Summerlin West Village 22-Kettle Ridge Drive
(Sheet J)

CITY OF LAS VEGAS INTER-OFFICE MEMORANDUM			DATE: January 21, 2021
TO: Land Development Services Department of Building & Safety			FROM: Albert Sung, P.E. Flood Control Project Engineer Department of Public Works
SUBJECT: Drainage Study for: Summerlin West Village 22 - Kettle Ridge Drive (Street J) (from Sunset Run Drive to Kindle Rise Way)			COPIES TO: Atkins Global
Cross Streets:	Kettle Ridge Drive and Sunset Run Drive		Howard Hughes Company, LLC.
File Number:	F:\Depot\DSMemos\DS5349C.doc		Bart Anderson, P.E., DevCo
Parcel Number:	137-23-210-001		CCRFC
Zoning Action:	N/A		
FEMA Flood Zone	YES	NO X	
Proposed Storm Drain	YES X	NO

Supplement to Addendum #1

RE: Supplement to Addendum 1 to the Technical Drainage Study for Summerlin West Village 22 Kettle Ridge Drive: Sunset Run Drive to Kindle Rise Way

Call before you Dig
AVOID CUTTING UNDERGROUND
UTILITY LINES. IT'S COSTLY.

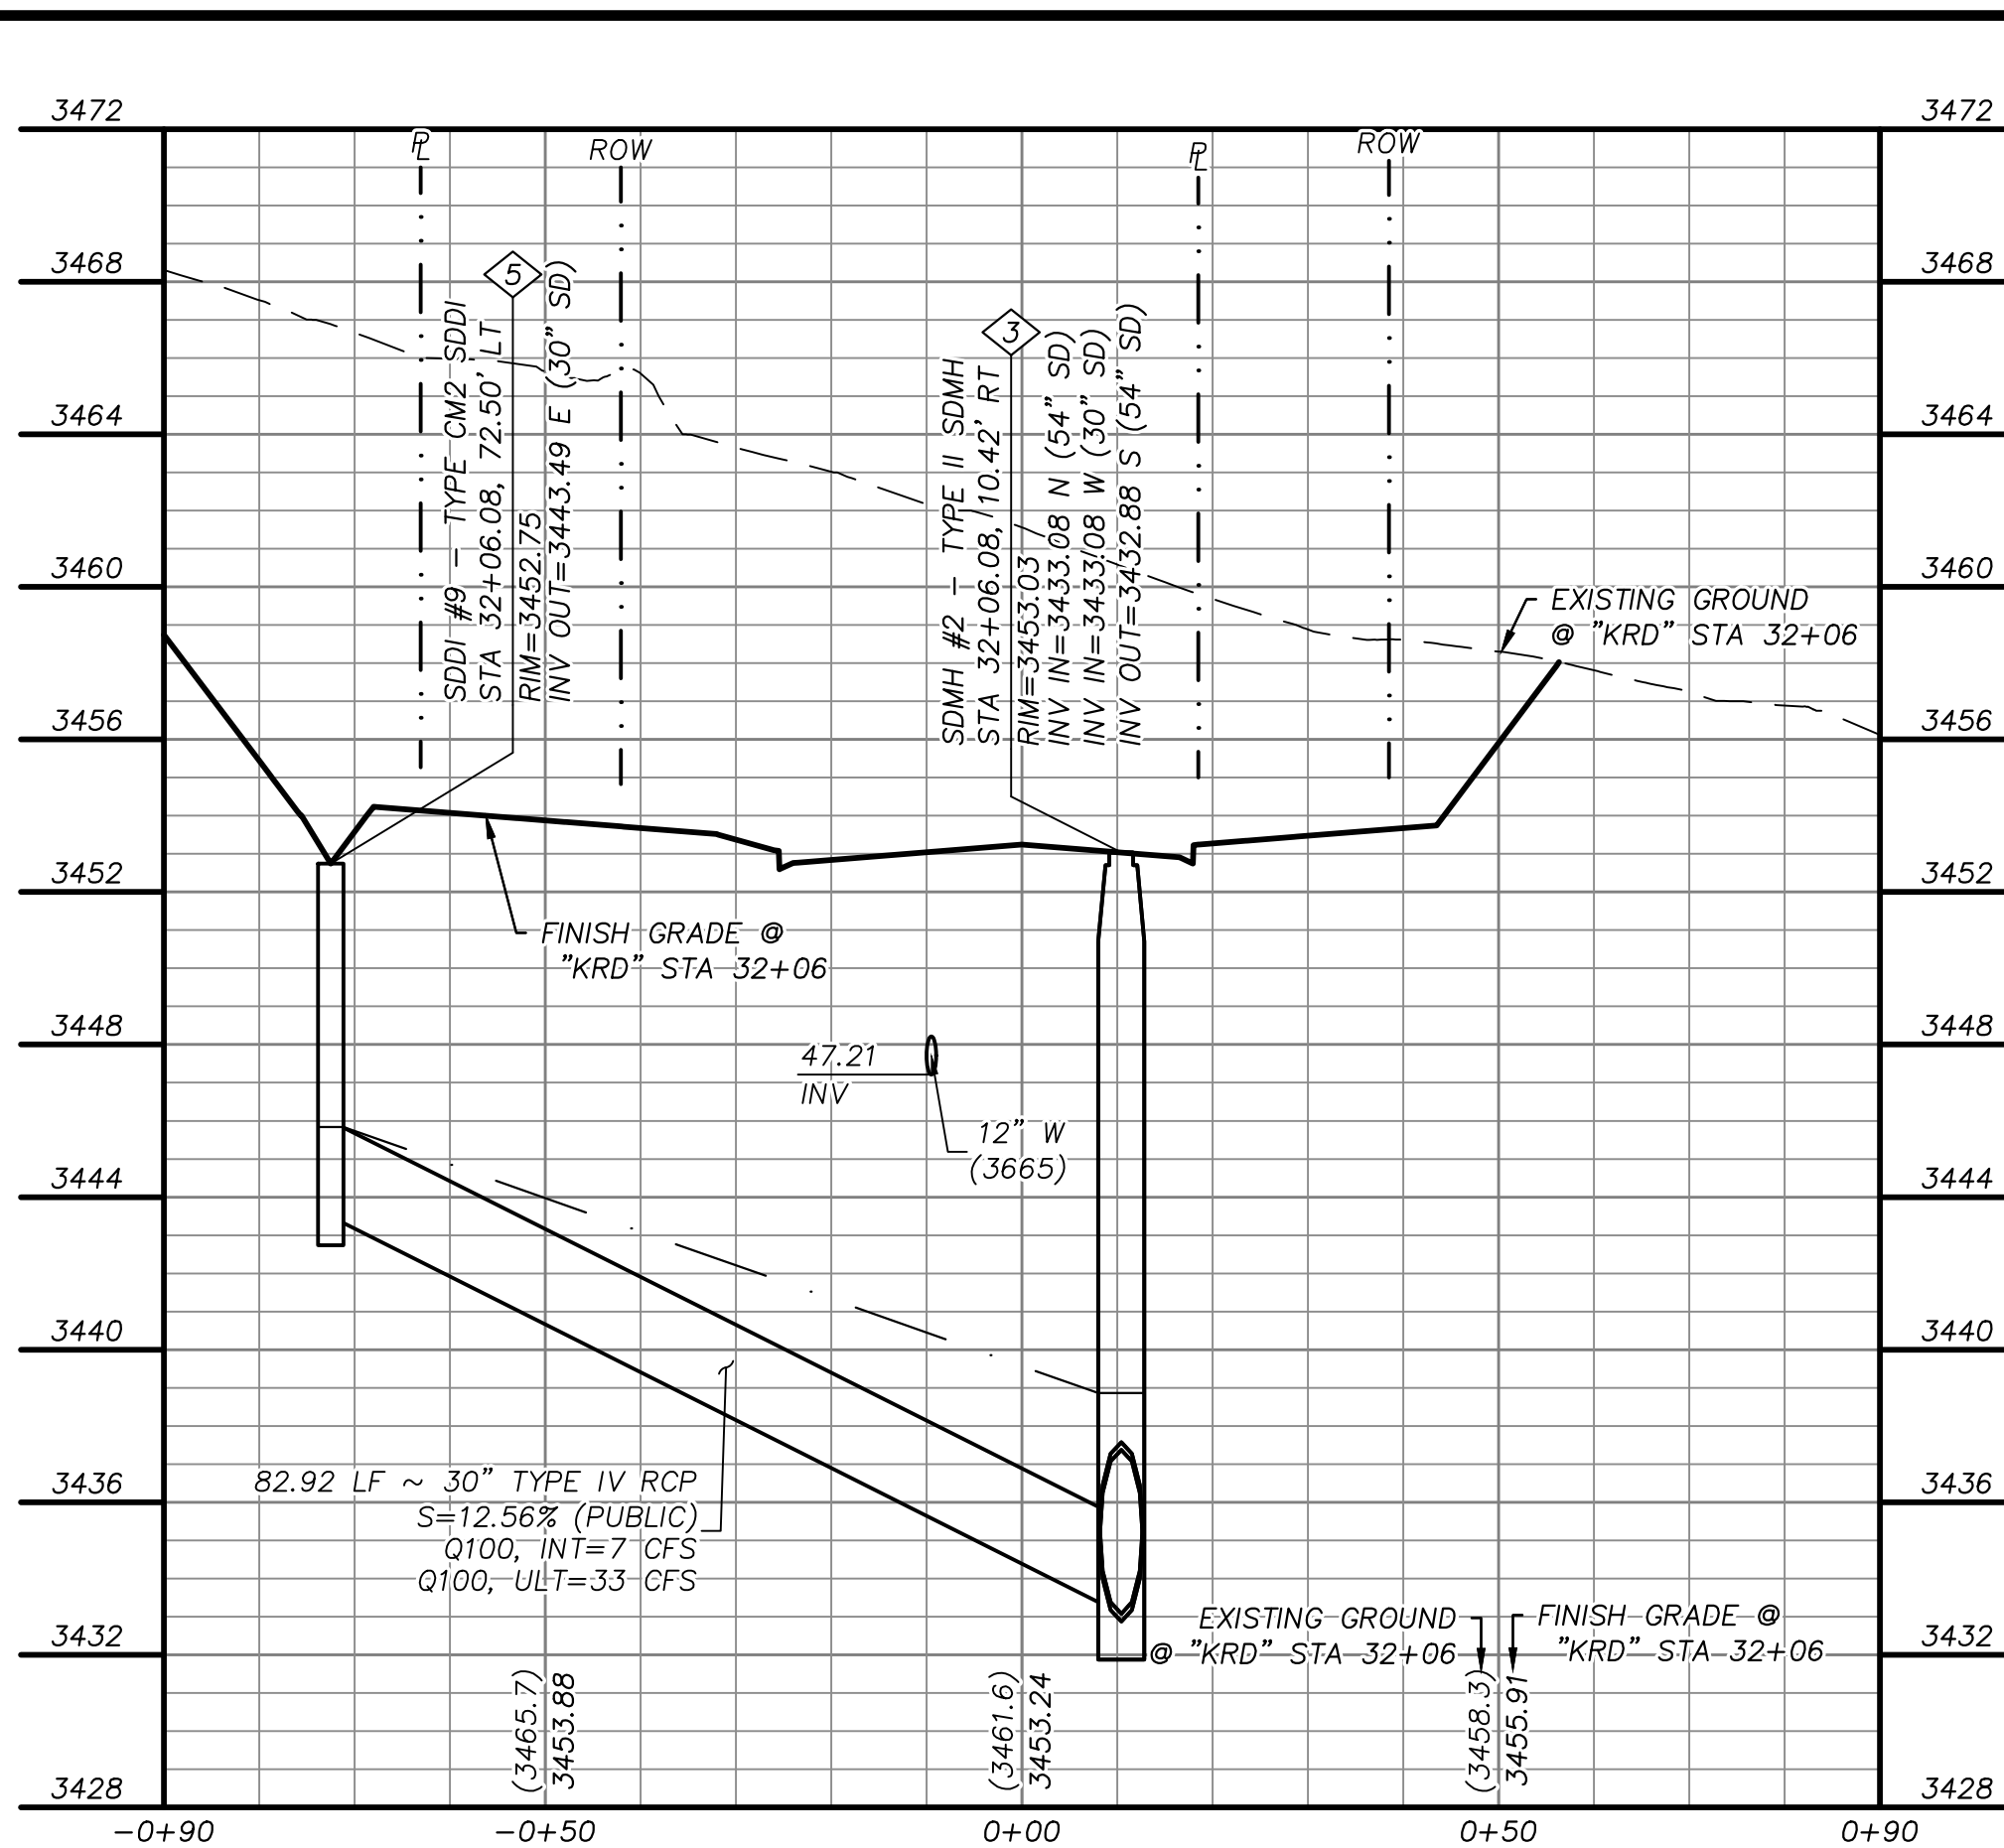
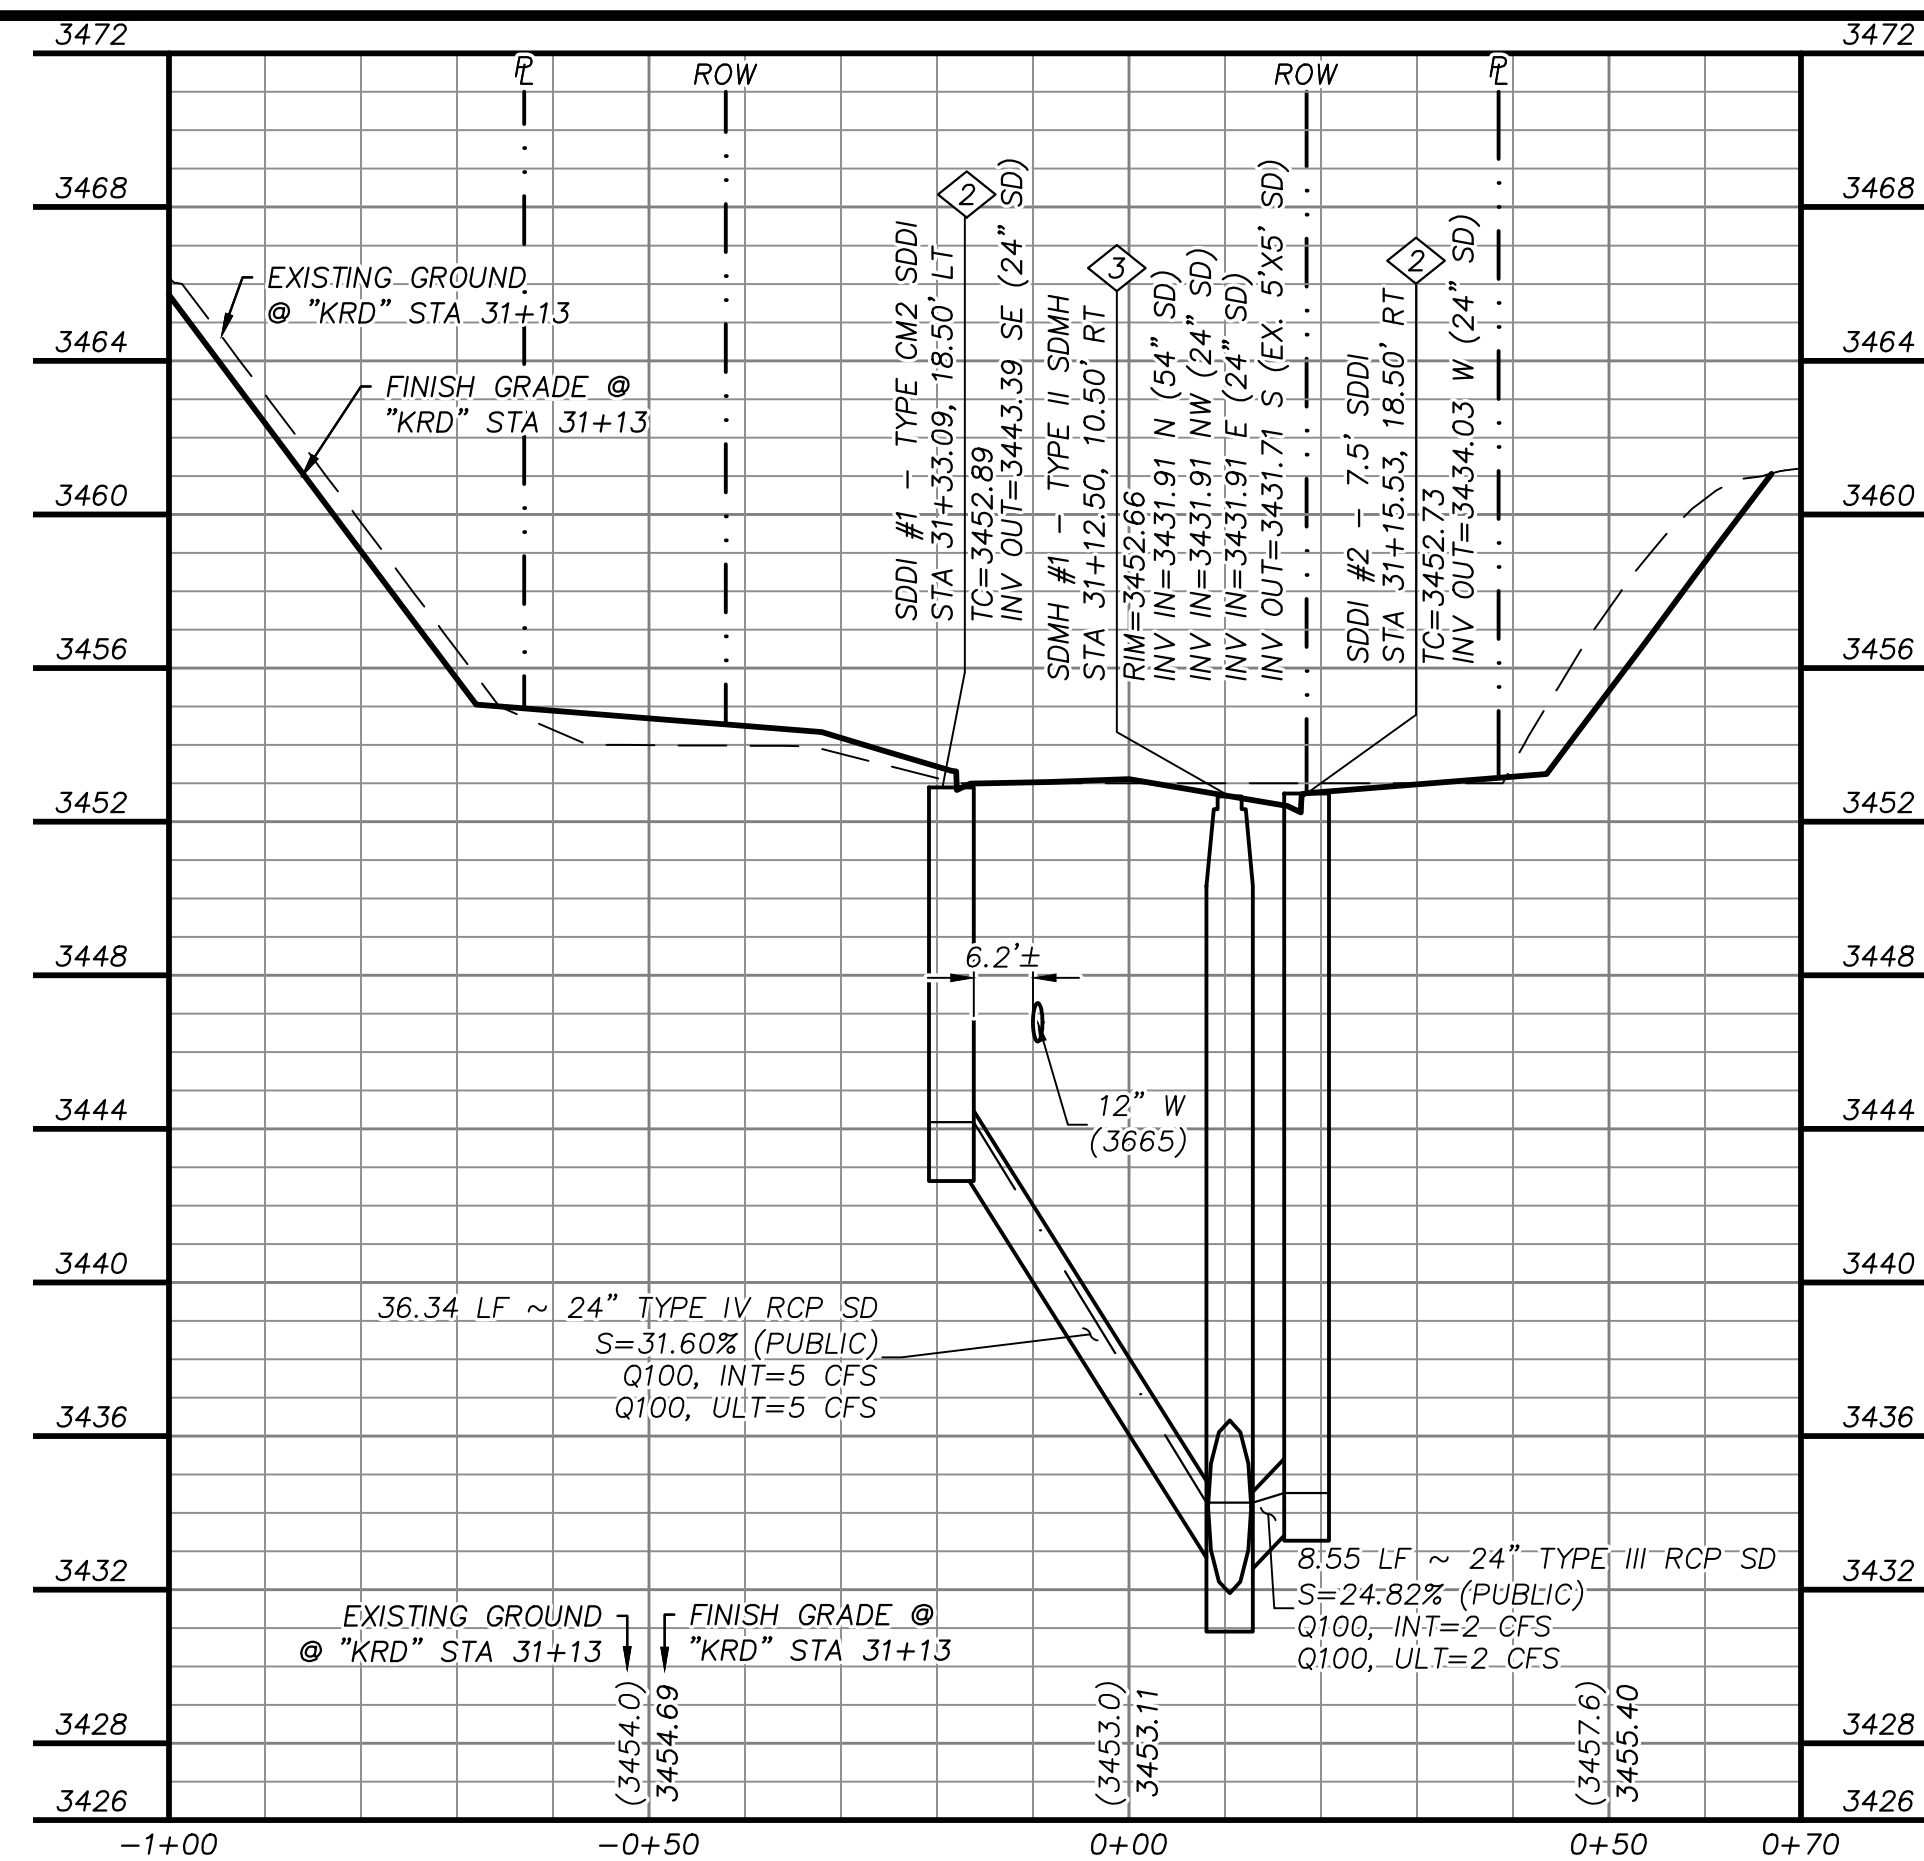
Comment #6: Previous Comment: Sheet 20/26 & Sheet 21/26: In general, the HGL shown on the profiles for the laterals do not match the calculations. For example: The HGL is lower than the base of the inlet for SDDI #10.

6. **Previous Comment: Sheet 20/26 & Sheet 21/26: In general, the HGL shown on the profiles for the laterals do not match the calculations. For example: SDDI #2: Calculation shows a lower water surface while the profile shows a much higher water surface. SDDI #5: The HGL is even lower than the base of the inlet. Same for SDDI #10.**

The response to SDDI #10 is still un-satisfactory: The HGL is still lower than the base of the inlet. Perform better quality control in the next submittal.

Comment response: SDDI #10 lateral has been revised to show the correct HGL. The associated WSPG-W output is included for review convenience.
